**SUBJECT:** **NEW VEHICLE DEMONSTRATION / DELIVERY HOLD - Safety Recall 17S15**  
**– Supplement #1**  
 Certain 2015-2017 Transit Vehicles Equipped with a Driveshaft Flexible Coupling  
 Driveshaft Flexible Coupling Repair

**REF:** **NEW VEHICLE DEMONSTRATION / DELIVERY HOLD - Safety Recall 17S15**  
 Dated June 27, 2017

**New! REASON FOR THIS SUPPLEMENT**

FIGURE 1a

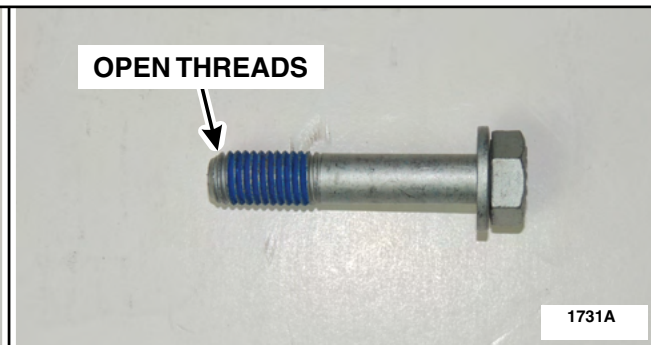
- The blue paint marking on the *new* driveshaft flexible coupling must be installed facing the transmission output flange or premature failure of the flexible coupling will occur. See Figure 1a.
